CONDITIONS OF APPROVAL:

Open Issues: 36 These issues are currently being filtered

136. Autoturn

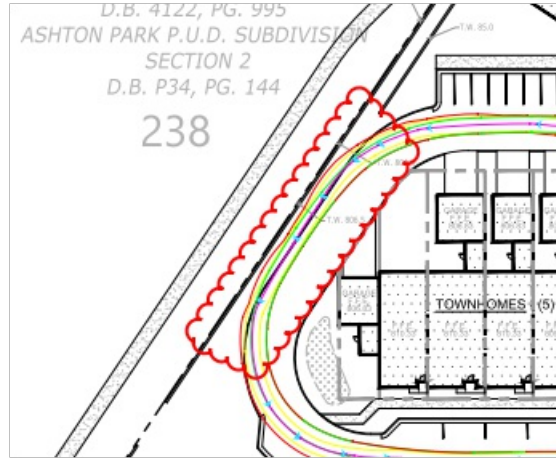
Applicant to correct the Autoturn on C4.17 such that the apparatus wheels are always on pavement.

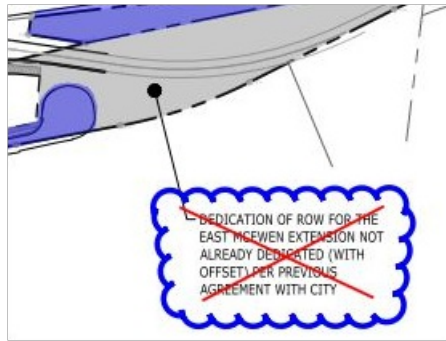
2. Show 'Future ROW' extending 2 feet beyond back of curb at the existing cul-de-sac in Garden Club Court. (C4.0, 4.15)

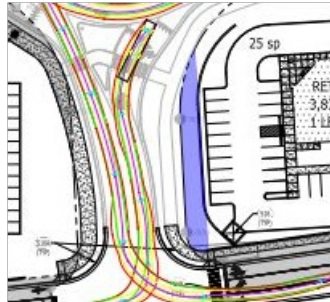
3. Remove note clouded below, and remove dedicated ROW between the cul-de-sac and that needed for the McEwen Extension. (C4.0, 4.14)

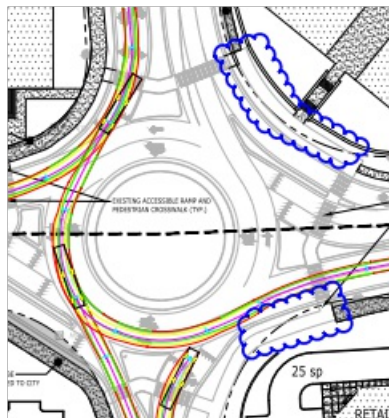
4. Show 'Future ROW' for the 12 feet needed for the additional lane at the south leg of the roundabout, per the TIA review. (C4.0, 4.14)

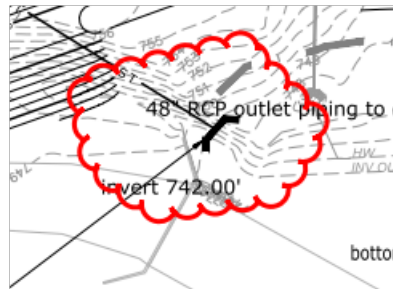
5. Show "Future ROW" for the sidewalks clouded below at the E. McEwen Drive / Cool Springs Blvd Intersection. (C4.14)

149. Storm Infrastructure

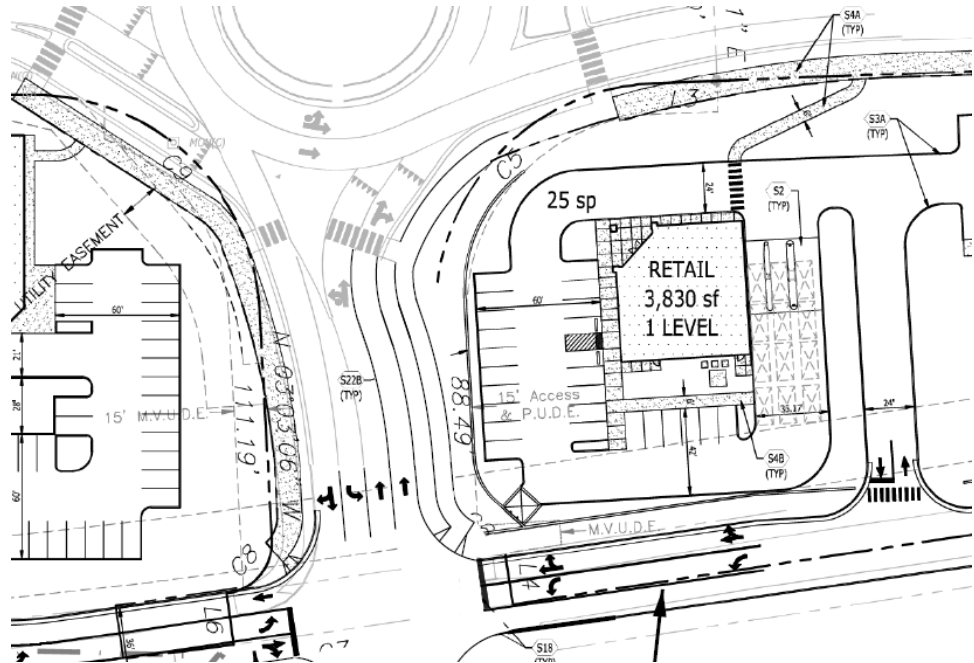
At the Site Plan stage, Applicant to shift the proposed junction box clouded below to be out of the turn lane. (C3.13). Additionally, the 54" RCP should be directed to discharge more parallel to the retaining walls adjacent to the bioretention areas instead of perpendicular, as schematically shown in the sketch above.

170. H. Stormwater Management Plan

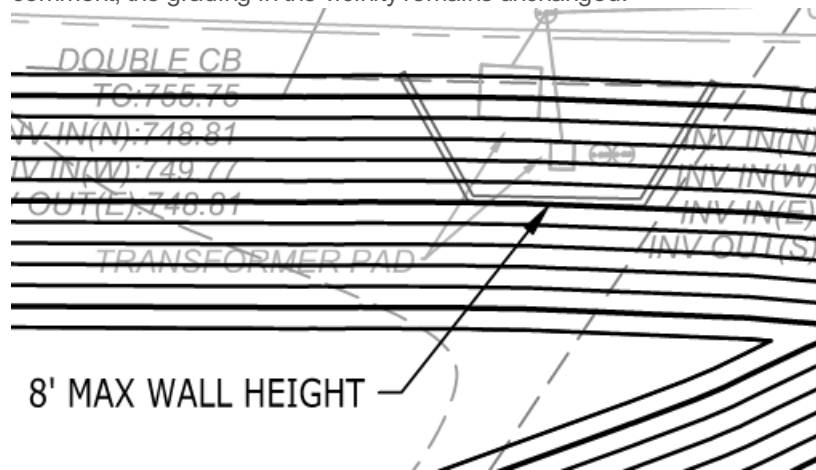
lance.fittro@franklintn.gov The previous comment has largely been addressed (thank you), but the box shown below which persists on sheet C3.18 shall be removed:

and another reference to TSS removal requirements remains in the narrative on sheet C3.01:

Applicant shall revise the narrative for the Northwest Residential Block to read "0.18 Effective Rv" rather than "82% TSS Removal".

173. G. Grading Plan

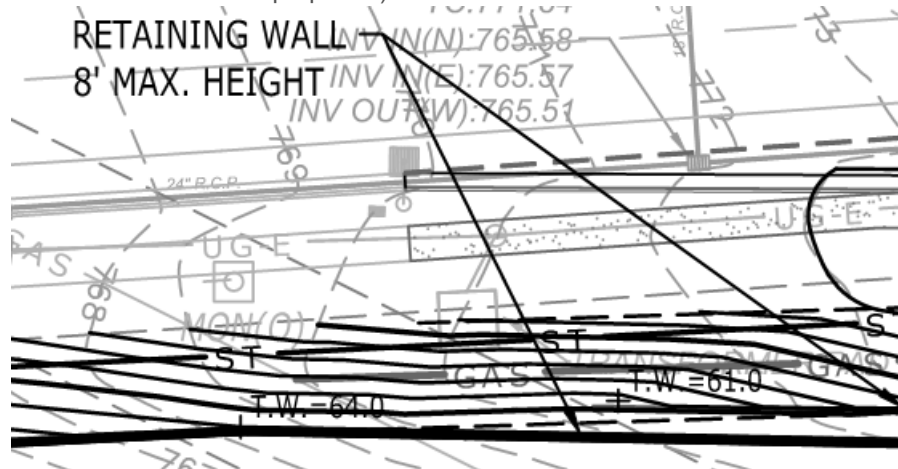
lance.fittro@franklintn.gov While a wall has been added around the transformer pad to address the previous comment, the grading in the vicinity remains unchanged:

A similar issue persists with the next transformer pad to the east (adjacent to the large bioretention installation proposed):

175. Easements

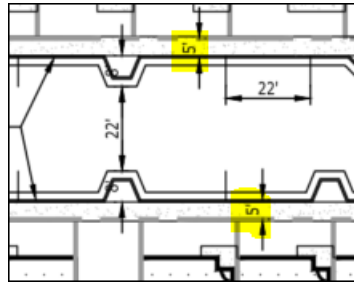
Applicant to show the easements immediately to the west of the development, including the TVA easement, on Sheets C2.0 and C2.17, similar to that shown on the previous submittal.

179. Site Plan

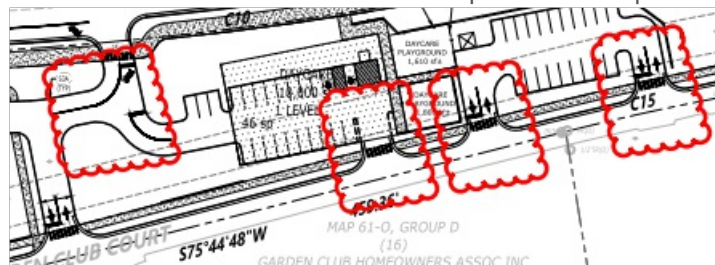
Advisory Comment: At Site Plan, the Applicant will be required to revise the drives and accesses clouded below to meet Street Specification requirements. (C2.15)

180. Driveway Length

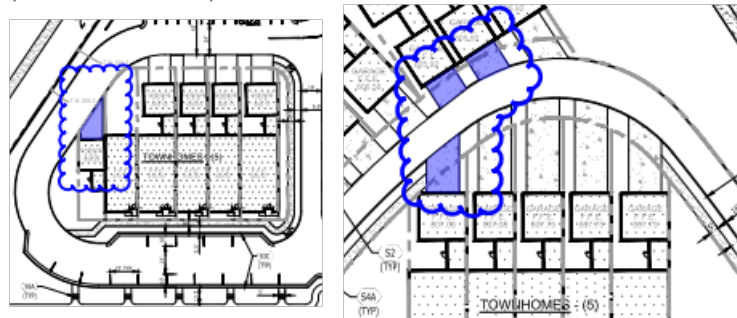
Advisory Comment: At Site Plan, the Applicant will be required to revise driveways such that all portions of driveway lengths are either 5 feet or less, or 20 feet or more, from the edge of pavement to the face of garage, including those highlighted below. (C2.17 and C2.18)

178. Architecture

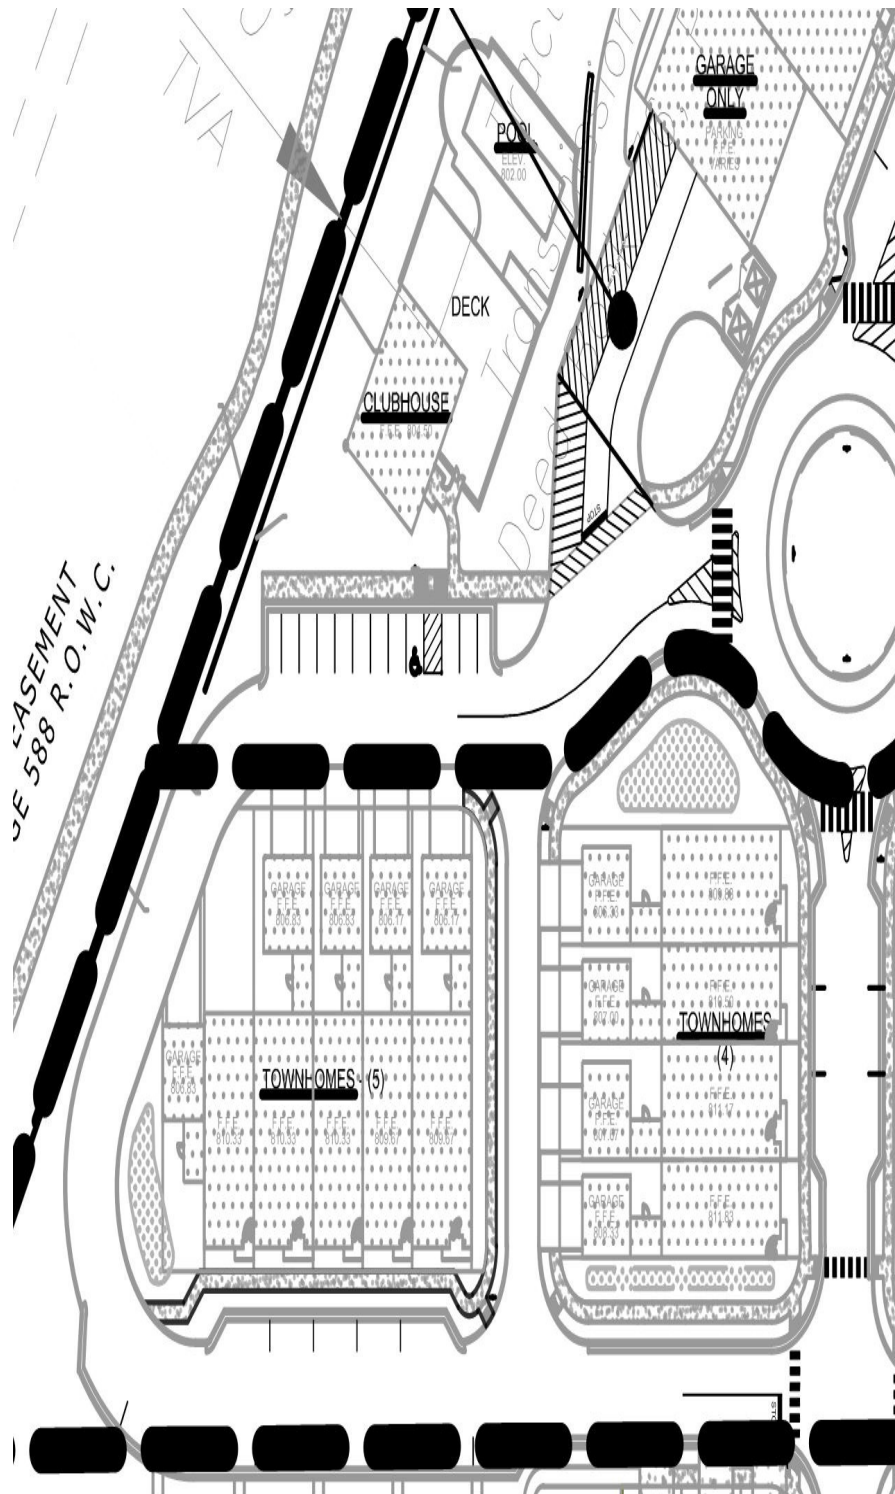
It is our understanding that the refuse center at the southwest corner of the development is to be a fully enclosed building, and not merely a screen wall as depicted in the plans. As such, the applicant shall change this label to reflect their design intent.

The applicant shall also be aware that this building will require elevations at site plan, meeting the standards of section 5.3.6 of the Zoning Ordinance.
